LYNAS SMITH

Section 73 - Minor Material Amendment

Section 73 Minor Material Amendments Application to Application 2015/3131/P

COMPARISON DOCUMENT

Ground Floor Plan - Consented

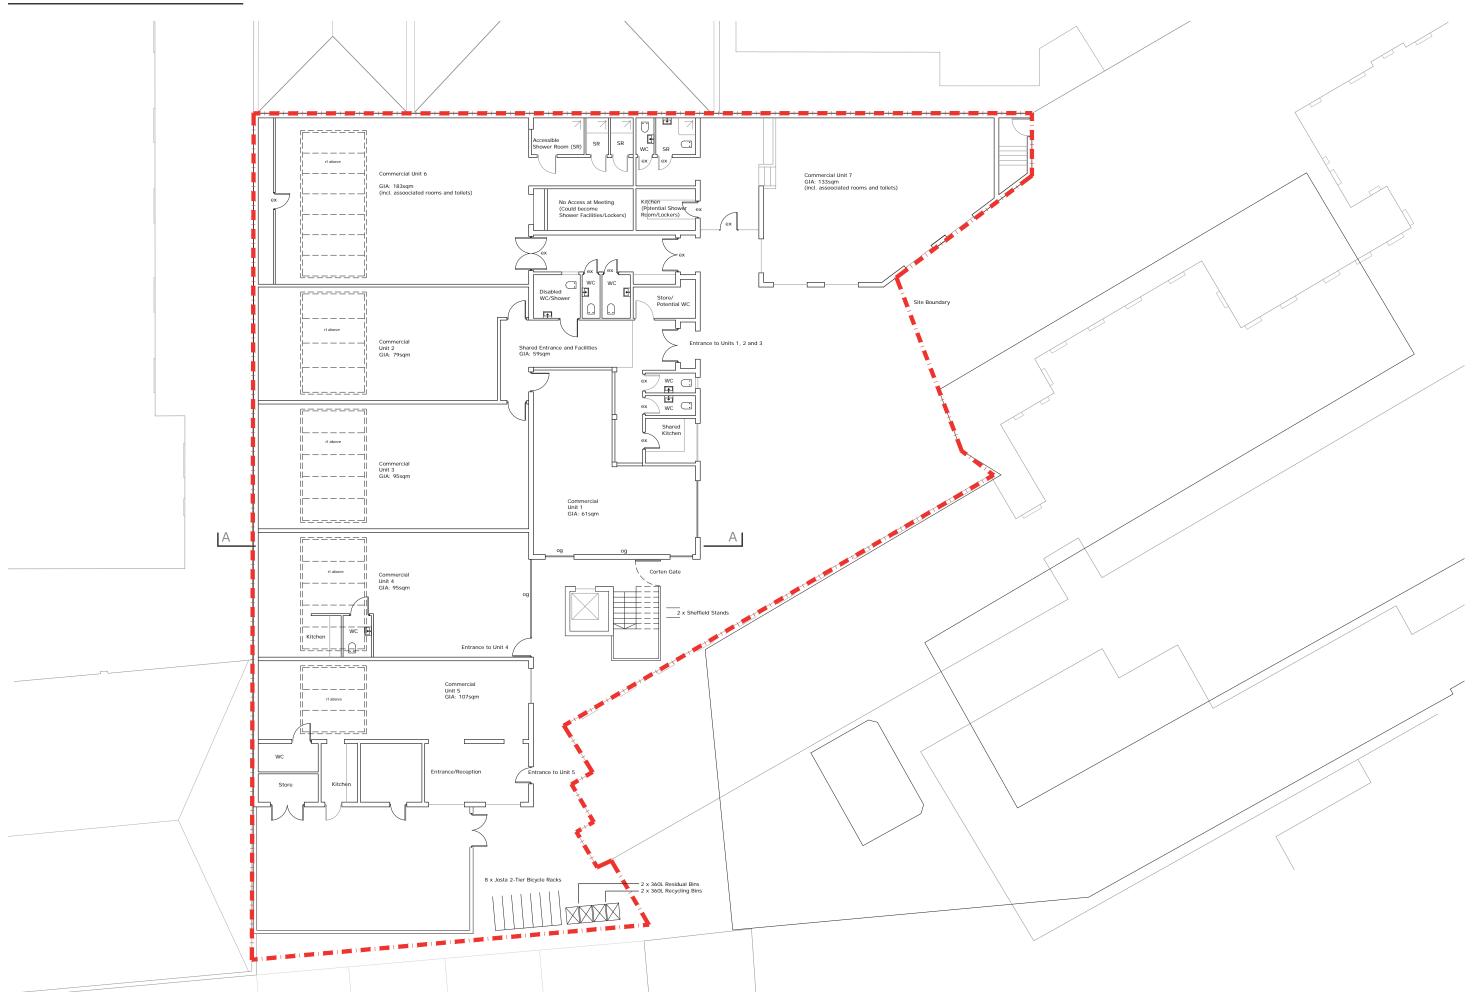
- Slatted timber vents have been incorporated into the cladding on the front and side elevation for venting of hidden plant equipment. (See P.19/P.21)
- -The external lift and stair core and enclosure has been redesigned to create a chamfer which aligns more elegantly with the neighbouring new hostel building, allowing for ease of access also to the side of the site where the bin and bike store are located. (See P.6/P.7)

- -A new vehicle and pedestrian gate has been added at the entrance to the site within our site boundary. (See P.6/P.7)
- -Unit numbers have been renamed to reflect design changes.

Proposed Section A-A

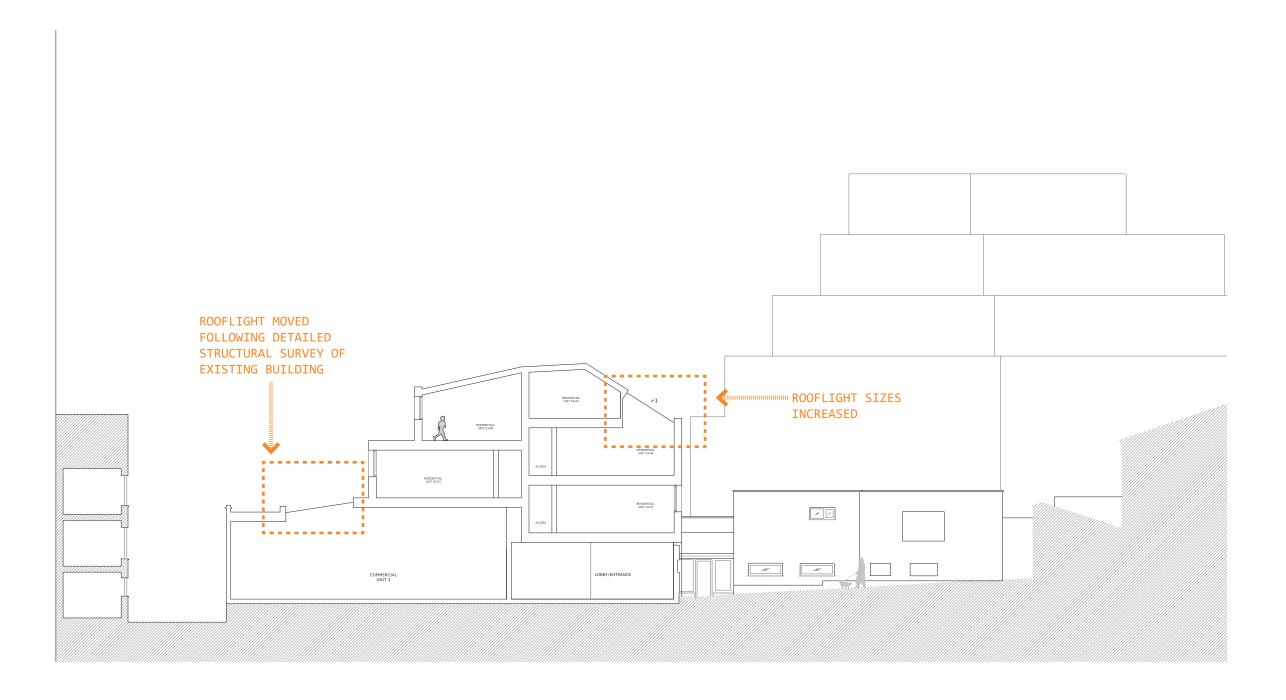
- -The skylights in the living areas of the top floor units have been enlarged to allow as much light to enter these areas. The consented glazing was 2400 x 1400 mm and the proposed is 3900×2300 . (See P.5 and P.14/P.15)
- -Where there are internal sloped roofs in the living areas, the windows have been increased to align with this slope and to align with the proposed rooflights. (See P.5 and P.20/P.21)
- -The layout of the apartments and the location of the windows on all elevations have been coordinated in accordance.
- -The south facing units at first floor have been reconfigured to remove the stair to the unit on second floor, allowing the one bedroom and three bedroom units to have better layouts. (See P.8/P.9)
